SUBJECT: Calvert Cliffs Nuclear Power Plant
Unit No. 2; Docket No. 50-318
Framatome Lead Fuel Assemblies – Temporary Exemption Request and License
Amendment Request

**ANALYSIS FOR USE OF M5™ CLADDING MATERIALS
IN CALVERT CLIFFS UNIT 2
BATCH T LEAD FUEL ASSEMBLIES**

Figure 1

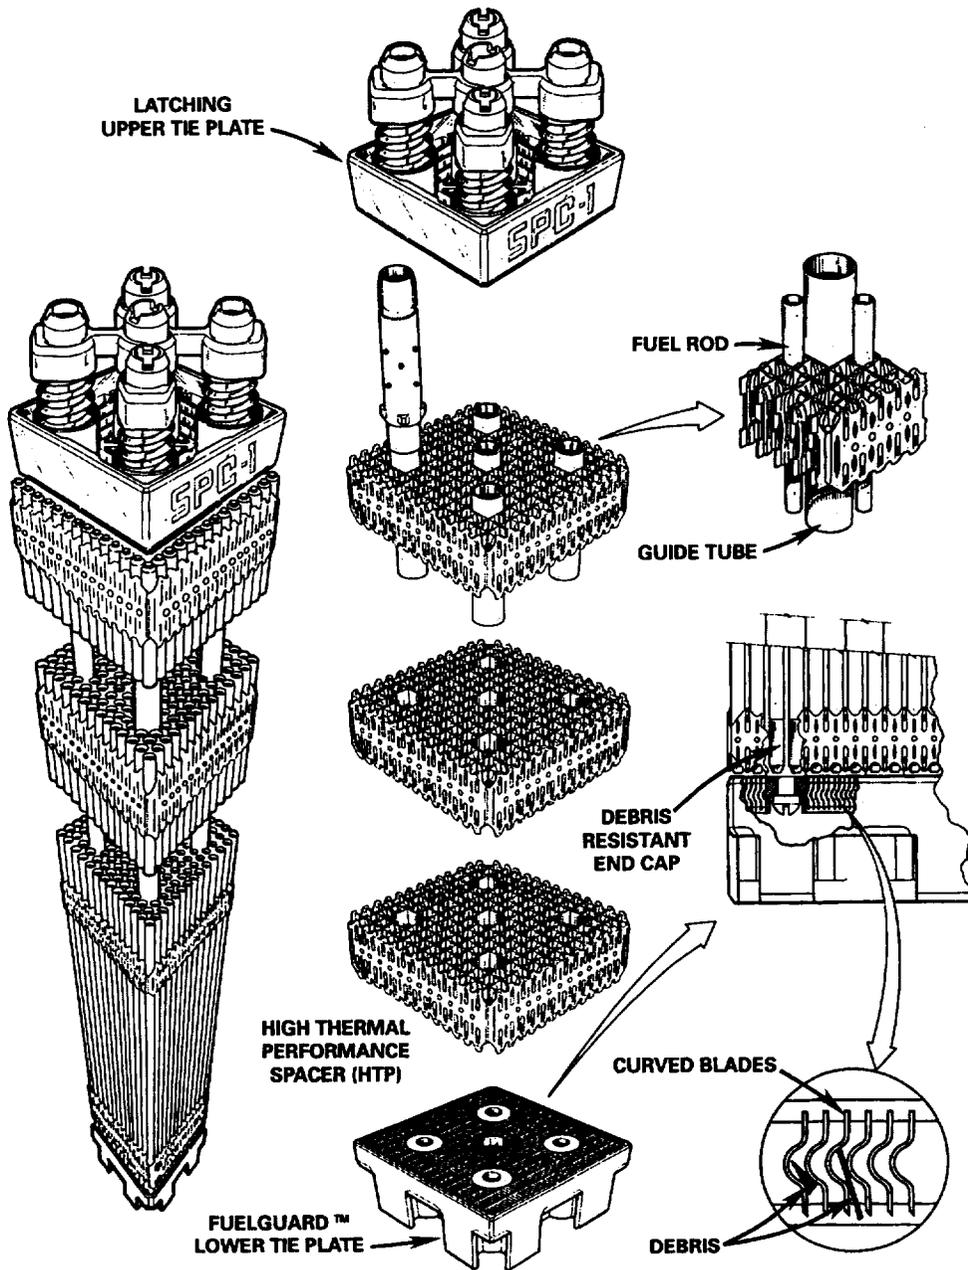
The LFAs for the Calvert Cliffs Unit 2 reactor will be the FRA-ANP CE 14x14 design. The bundle uses nine Zircaloy-4 grid spacers of the high thermal performance (HTP) design. The lower tie plate is the FUELGUARD™² design, and the upper tie plate is the standard, reconstitutable FRA-ANP design for CE 14x14 fuel. The HTP spacer was generically reviewed and accepted by the NRC and has been used for reload designs for CE, Westinghouse, and Kraftwerk Union reactors since 1991. The FUELGUARD lower tie plate has also been used in reload designs for CE, Westinghouse, and General Electric designs. The reconstitutable upper tie plate design has been in use for reloads for CE plants since the early 1980's. Except for the changes to the fuel rod described in the following paragraphs, the LFA fuel bundle design has been used in reloads for other CE 14x14 plants. An illustration of this design is shown in Figure 1.

- Cladding material used for the fuel rod is M5 instead of Zircaloy-4
- Cladding inner diameter is increased by 0.003 inches to 0.387 inches
- Pellet diameter is increased by 0.0035 inches to 0.3805 inches
- Pellet density is 96% theoretical density instead of 95.35% theoretical density
- Initial rod internal pressure will be increased from 315 psig to 375 psig
- Cladding length is increased by about 0.2 inches
